AMENDMENTS TO THE DRAWINGS

Appl. No. 10/781,523 Amdt. Dated Feb. 2, 2006

Reply to Office Action of 11/08/2005

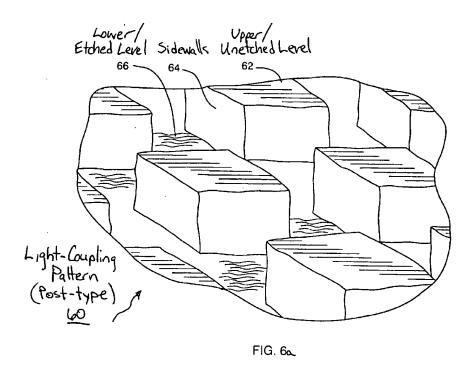
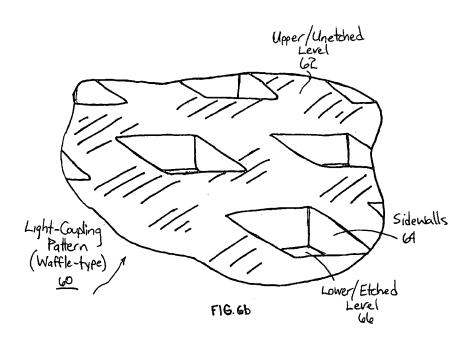
- FIG. 1 handwritten text replaced with typed text
- FIG. 2 handwritten text replaced with typed text
- FIG. 4 handwritten text replaced with typed text
- FIG. 6a handwritten text replaced with typed text; label "Light-Coupling Pattern (Post-type) 60" has been amended to "Light-Coupling Pattern (Post-type) 70" to more clearly distinguish the post type grating from the waffle type grating.

- FIG. 6b handwritten text replaced with typed text; label "Light-Coupling Pattern (Waffle-type) 60" has been amended to "Light-Coupling Pattern (Waffle-type) 80" to more clearly distinguish the post-type grating from the waffle-type grating.

In more particular detail, Applicant has amended Figure 6a to denote the post-type grating as element 70 and the waffle-type grating of Figure 6b is denoted as element 80. Figure 7a has been amended to include a reference label for "Pixel 90" to note that the structure is a pixel. This aids in understanding the orientation of the grating 60 on the pixel 90, wherein the grating is oriented to the edges of the pixel 90. Reference number "60", "62", "66" has been added to more clearly identify the "Light-Coupling Grating Pattern 60" and the "Posts 62" and "Wells 66". The term "Holes" has been amended to "Wells" to more clearly identify the well structures. This is for clarification purposes and corresponding changes to the specification are included herein.

Applicant believes that the specification and drawings clearly illustrate a waffle configuration, wherein the structure resembles a waffle having wells instead of posts. For illustrative purposes, Applicant directs the Office to Figures 6a and 6b of the present application which are presented herein. Figure 6a shows a number of posts while Figure 6b shows a waffle configuration with wells etched out, leaving the grid lines in relief to form the sidewalls of the wells and the lower level forming the floor.

posts to leave the posts. For clarification purposes, the claims have been amended to match the specification description with respect to 'wells' in stead of 'holes', as the wells of the present invention have sidewalls (Fig. 6b - 64) and a lower level (Fig. 6b - 66)

FIG. 2

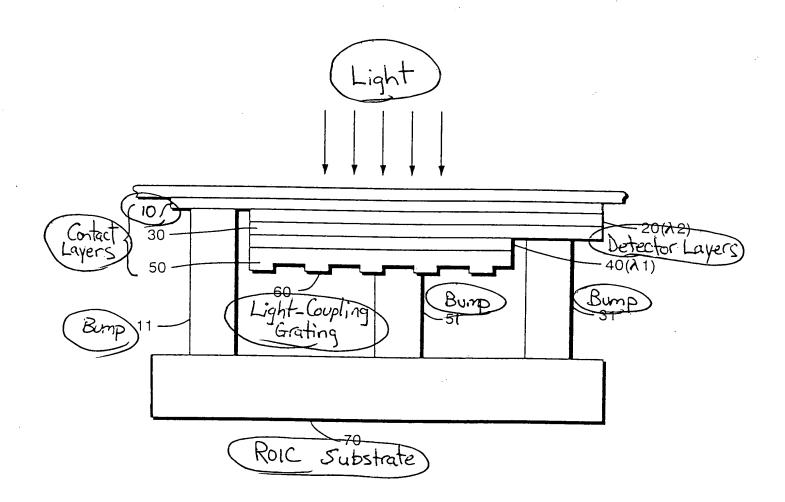
Handwritten text replaced with typed text
